CUBEX LTD. PRODUCT UPDATE

BULLETIN: PU-0006

SUBJECT: LE ROI UNLOADER AIR REGULATOR #CP18016

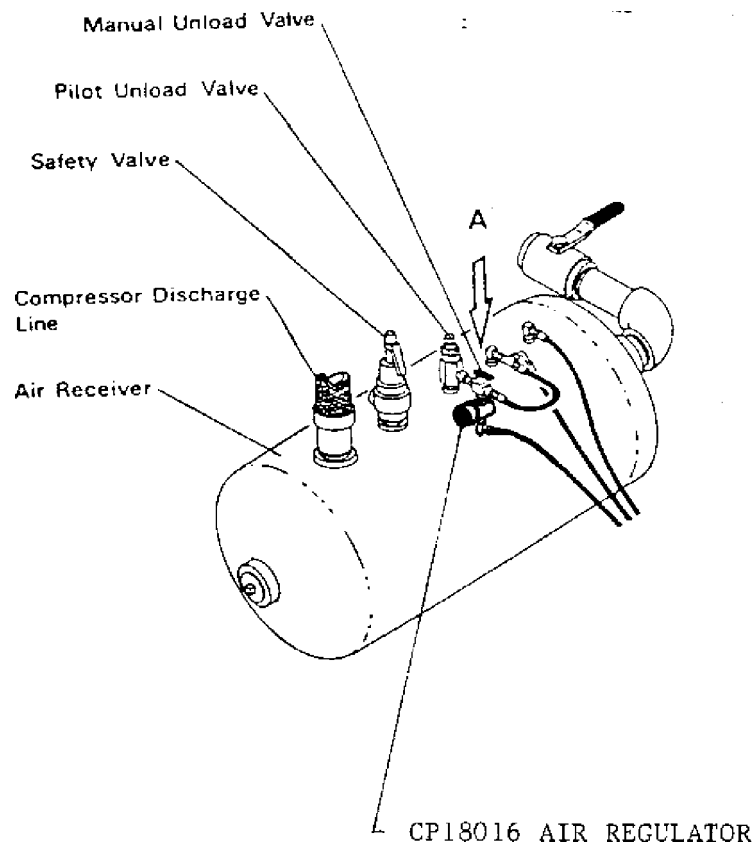
INFORMATION: This regulator is installed in the air line between the pilot unloader valve and the compressor unloader mechanism. This regulator will give longer life to the intake valves.
